REMARK**Status of Claims**

Drawing Changes

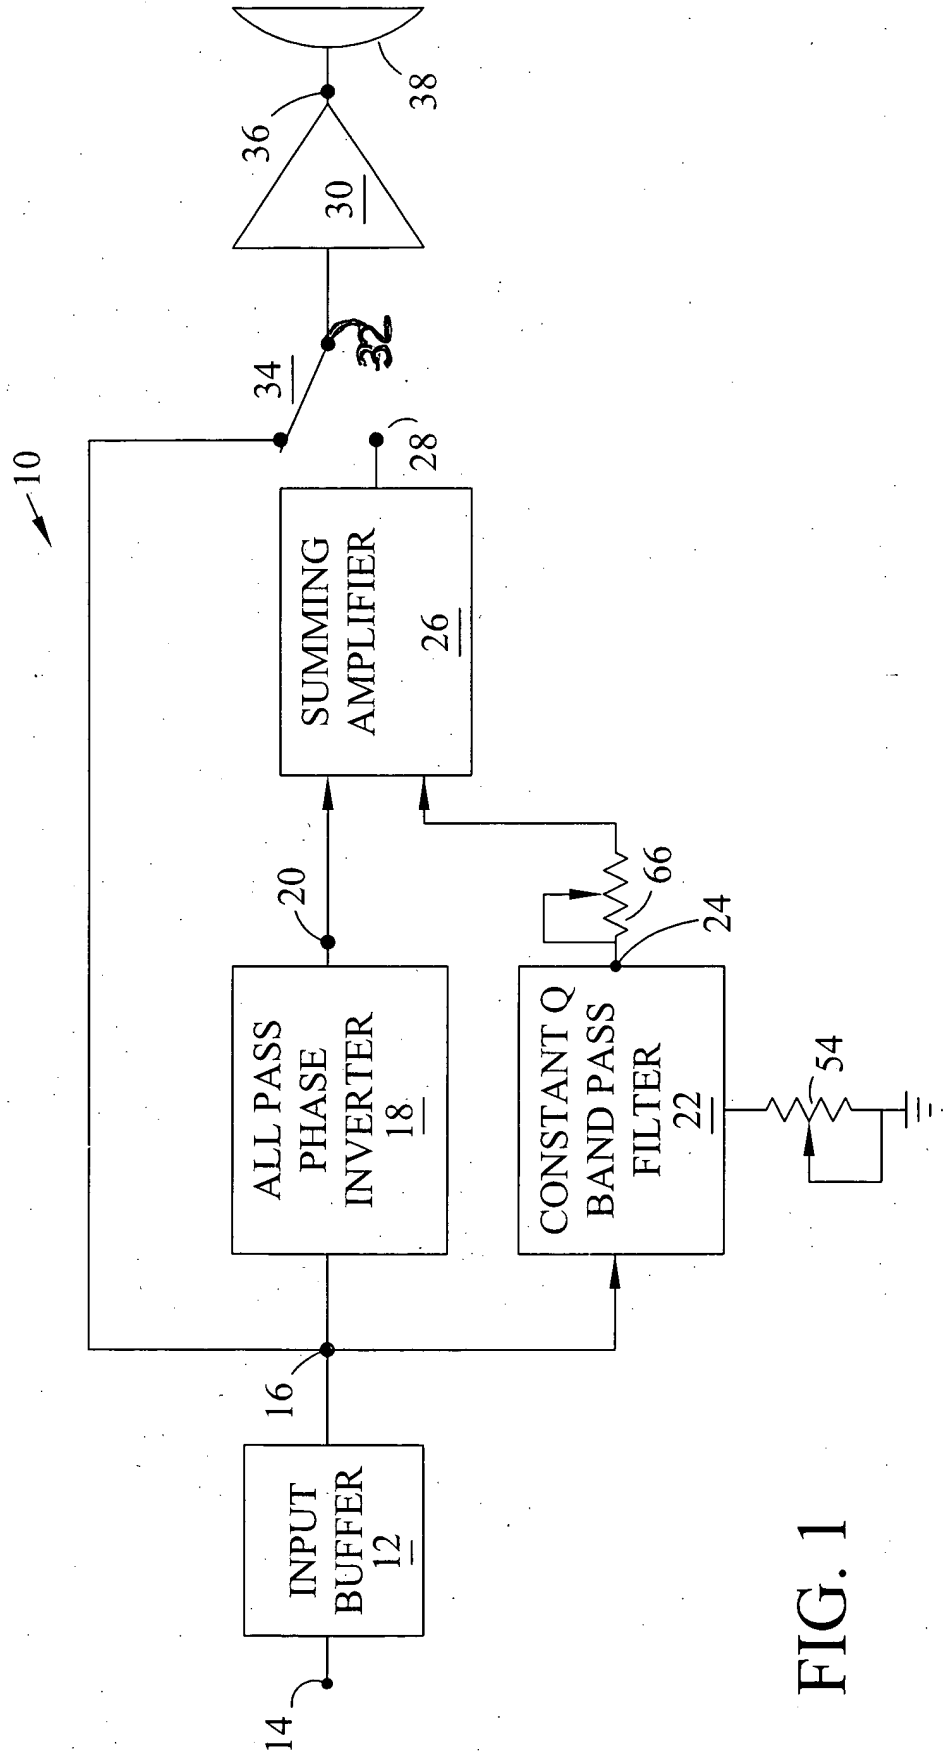
Figure 1 is amended to add reference number 32 to identify the transfer contact of switch 34. Reference number 32 is used in the specification at page 5, line 17.

FIG. 2

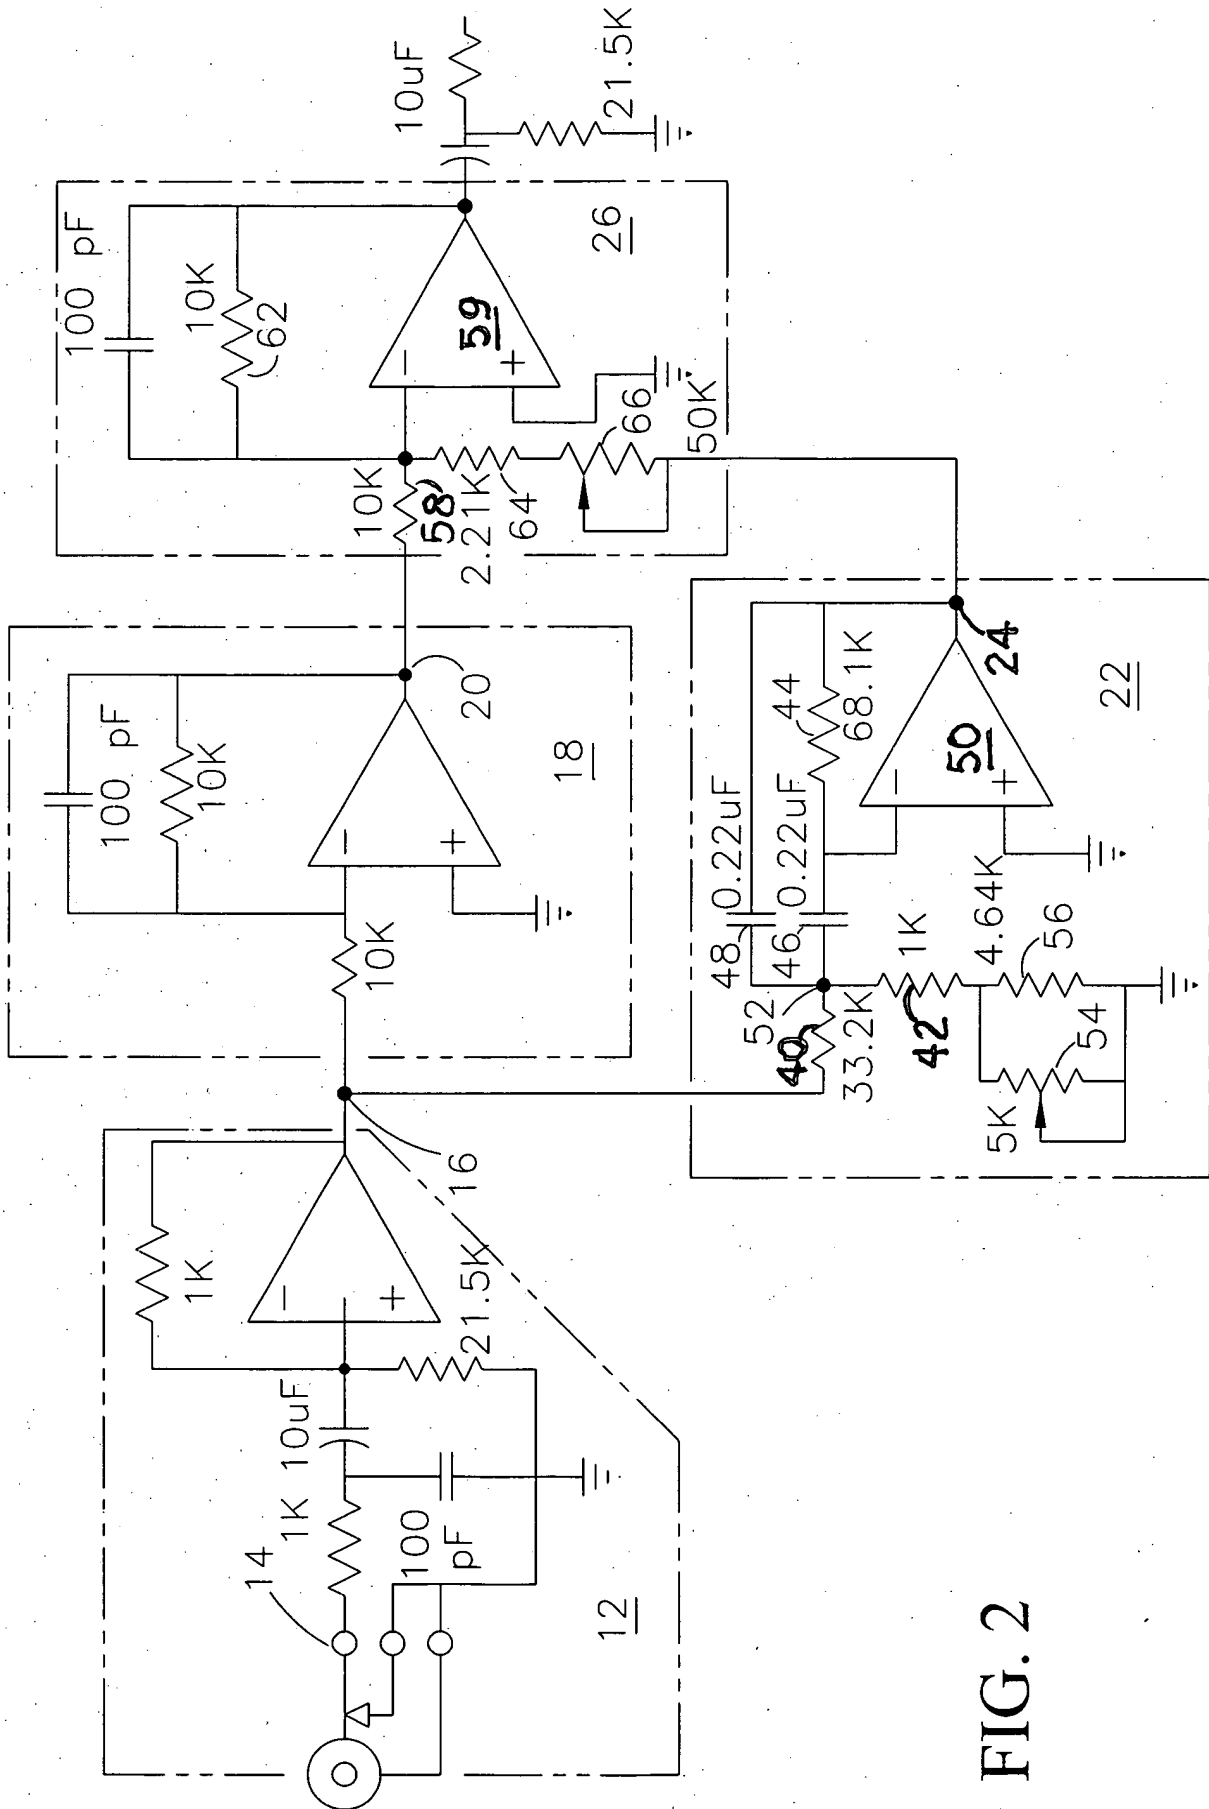
Figure 2 is amended to move reference number 20 slightly to the left and to add reference number 24 to the output of the Bandpass filter 22. Reference number 58 is added to top input resistor of integrator 26. Reference number 59 is added to the operational amplifier in integrator 26. Reference number 50 is added to the operational amplifier in the Bandpass filter in phantom block 22. Reference numbers 40 and 42 are added to identify resistors in phantom block 22.

FIG. 3

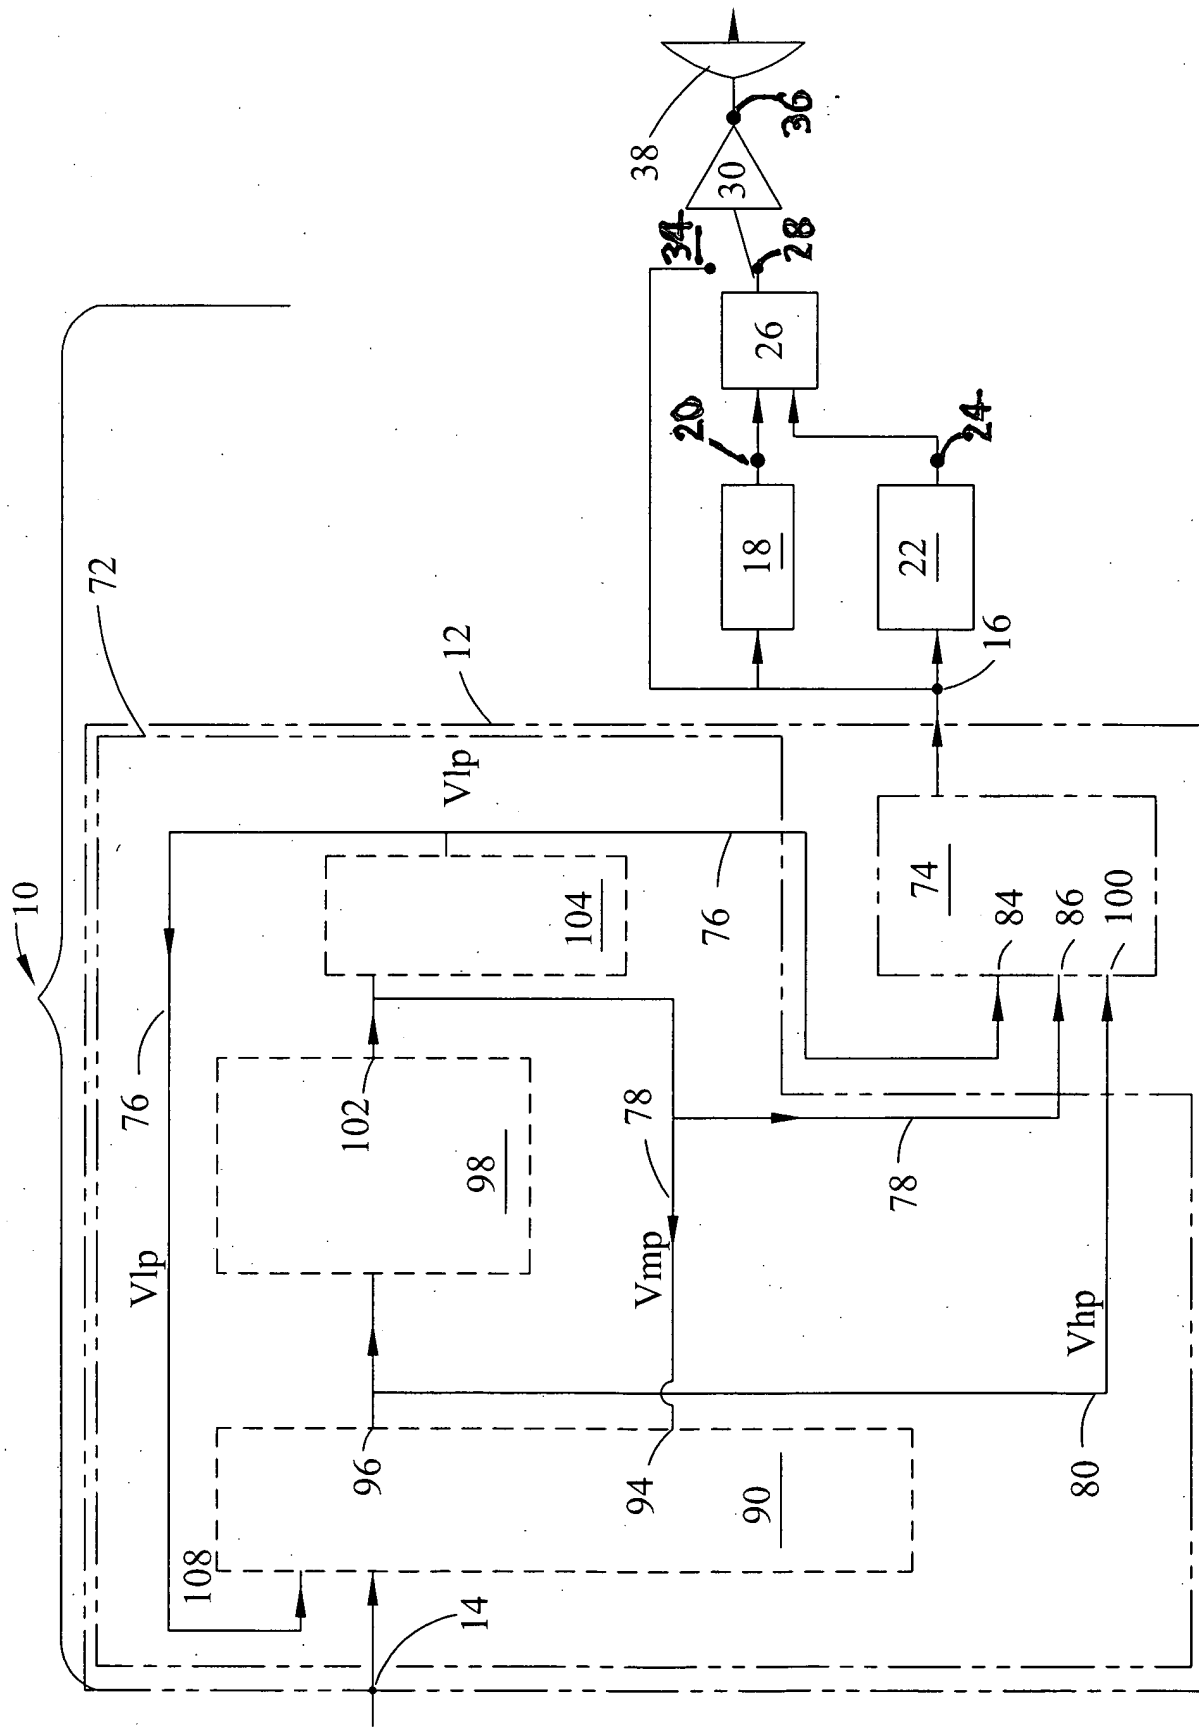
Figure 3 is amended to add reference number 20 to the output of block 18 and to add reference number 24 to the output of block 22. Reference number 28 is added to the output of block 26. Reference number 36 is added to the output of power amplifier 30. Reference number 34 is added above switch 34. Original Figure 1 shows the added reference numbers at the amended locations.

FIG. 4

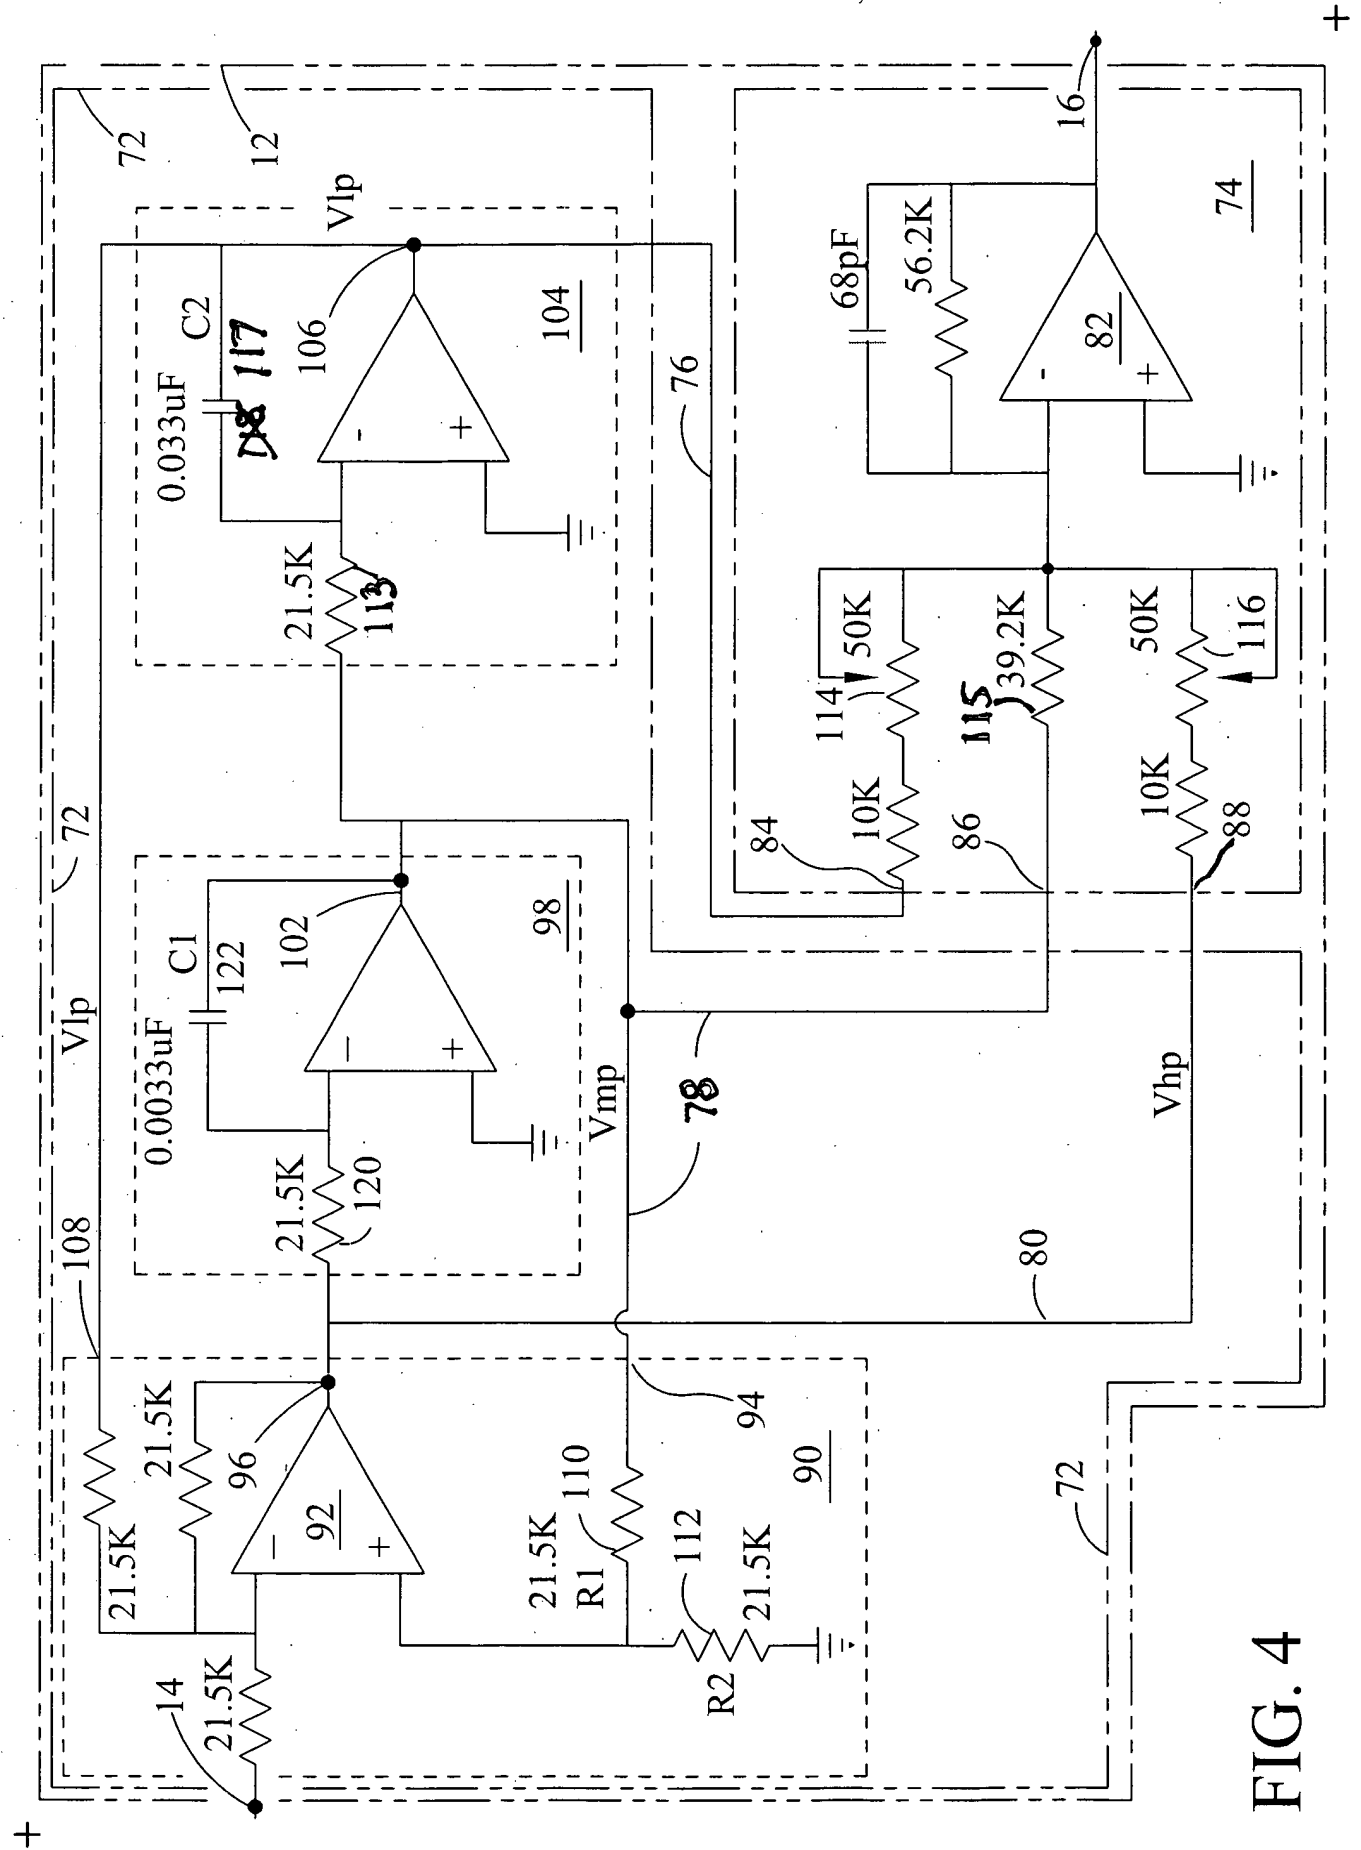
Figure 4 is amended to change reference number 70 to be 78 to be consistent with Figure 3. Reference number 115 is added above the mid-range input to the Summer 74.
